RE: FOUNDATION INVESTIGATION FOR PROPOSED  
THUNDER BRIDGE, CREDIT RIVER, 6th SIDEROAD,  
CALEDON TOWNSHIP, ONTARIO.

## FOUNDATION INVESTIGATION FOR PROPOSED THUNDER BRIDGE, CREDIT RIVER, 8th SIDEROAD, CALEDON TOWNSHIP, ONTARIO.

Re: Proposed Thunder Bridge over  
Credit River, 8th Ridgeway,  
Caledon Twp.

Re: Thunder Bridge over Credit River  
8th Sideroad,  
Caledon Township.

Engineering Data Sheet for Borehole: 1

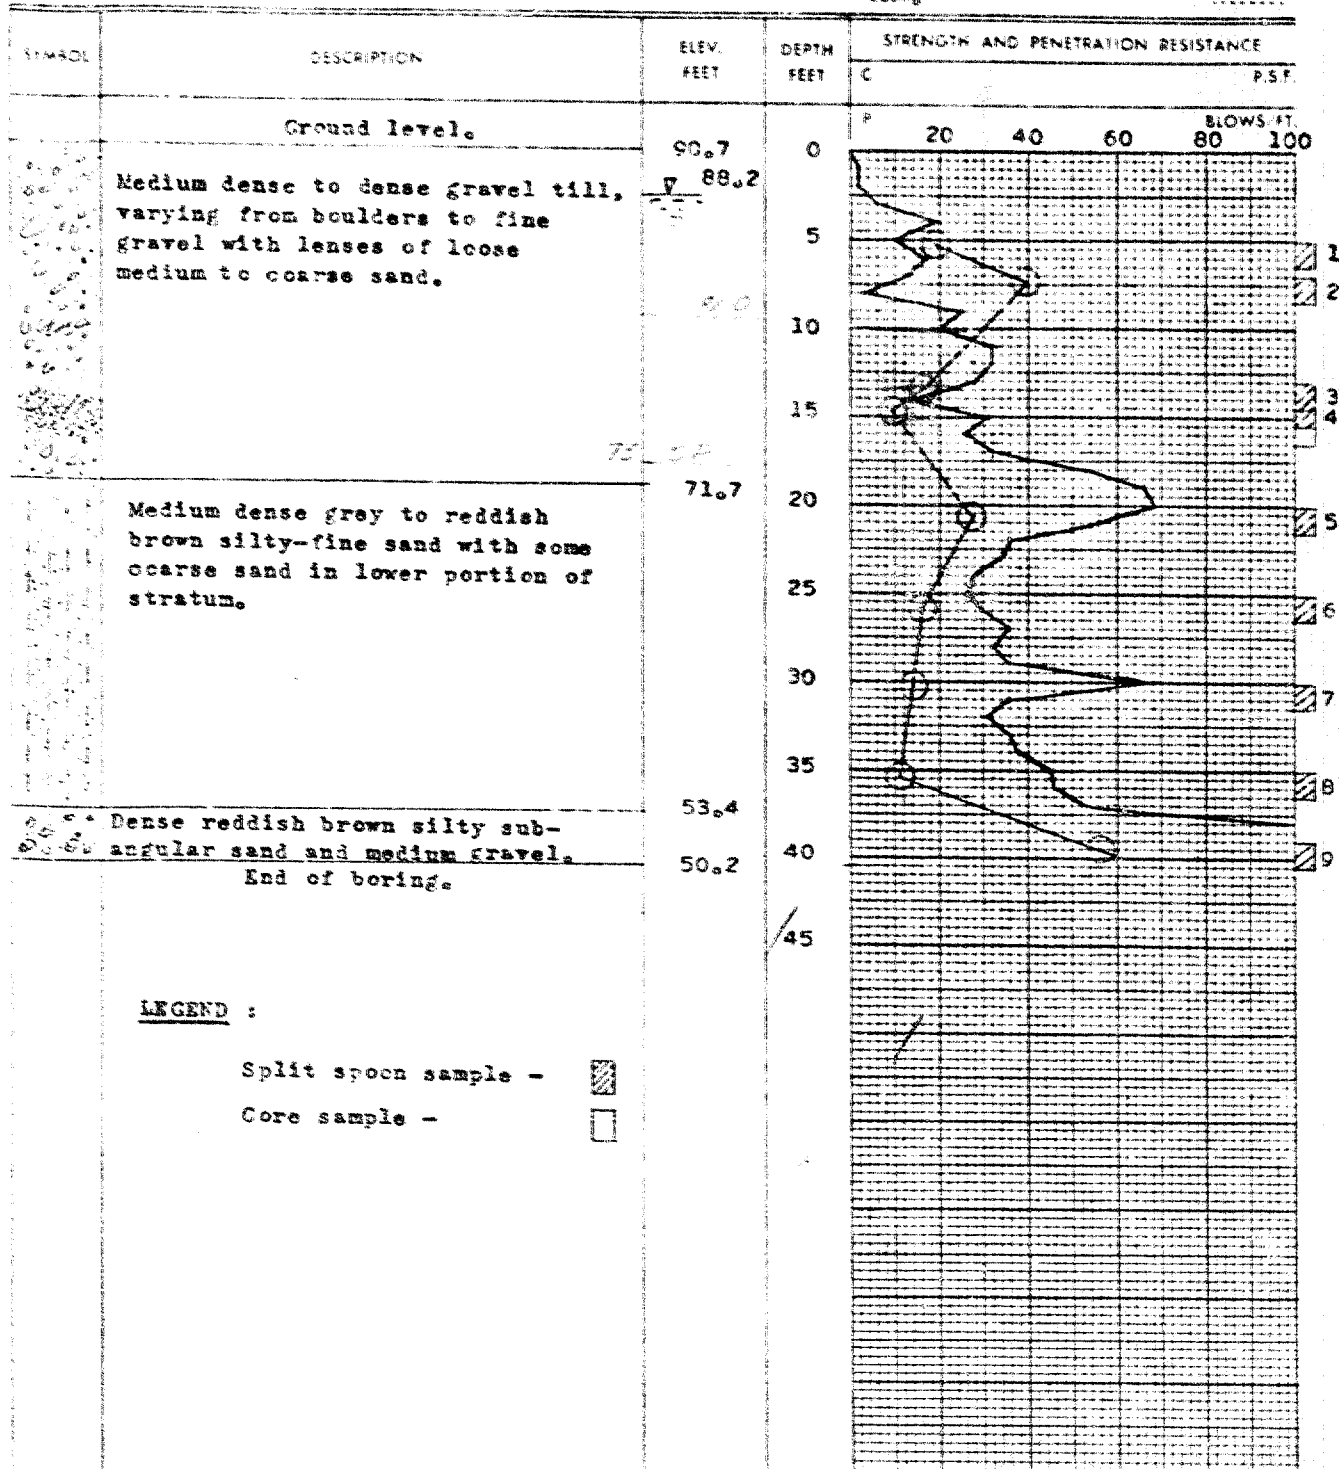
In Borehole No 3 a less pervious deposit of dense to medium dense grey to reddish brown silty fine sand was contacted at Elevation 60.1 feet. Between Elevation 71.7 feet and 53.4 feet in Borehole No 1 18 feet of this material was passed through and contact then re-established with the dense glacial till.
